# Access Compliance Report

## Public Rights-of-Way

Intersection ID: 31372	Main Street: GREENWAY_VISTA_LN	Cross Street: MCINTYRE_RIDGE_DR	Location: W
ADA ID: D778AEE4AE7C	Ramp Type: Perp	Initial Pass/Fail: Fail	Overall Compliance: No
Severity Score: 17.5			
Codes/Mitigation Info/Possible Solution		Field Measurements/Component Compliance

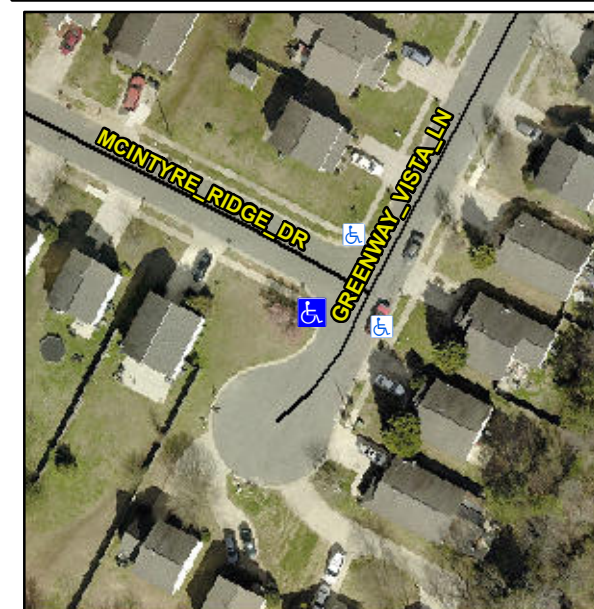
**Remove & Replace Entire Ramp.**

**R304.5.1**

Compliance	Description	Data	Compliance	Description	Data
N/A	Ramp Length (in)	49.0	Yes	Ramp Slope (%)	7.8
No	Ramp Width (in)	35.5	Yes	Ramp XSlope (%)	1.9
N/A	Flare Type LT	N/A	N/A	Flare Type RT	N/A
N/A	Flare Slope LT (%)	N/A	N/A	Flare Slope RT (%)	N/A
N/A	Flare Traversable LT?	N/A	N/A	Flare Traversable RT?	N/A
N/A	Landing Length (in)	N/A	N/A	DWS Provided?	N/A
N/A	Landing Width (in)	N/A	N/A	DWS Contrast?	N/A
N/A	Landing Slope (%)	N/A	N/A	DWS Length (in)	N/A
N/A	Landing X Slope (%)	N/A	N/A	DWS Full Width?	N/A
N/A	Landing Curb? (Y/N)	N/A	N/A	DWS Offset (in)	N/A
N/A	Shared Landing?	N/A			
N/A	Gutter Ponding?	N/A	N/A	Gutter Slope (%)	N/A
N/A	Gutter Lip Ht (in)	N/A	N/A	Gutter X Slope (%)	N/A
N/A	Painted X Walk1?	No	N/A	Painted X Walk2?	N/A
	X Walk 1 Direction	To SE		X Walk 2 Direction	N/A
N/A	X Walk 1 Width (in)	N/A	N/A	X Walk 2 Width (in)	N/A
	X Walk 1 Slope (%)	6.0		X Walk 2 Slope (%)	N/A
	X Walk 1 X Slope (%)	1.1		X Walk 2 X Slope (%)	N/A
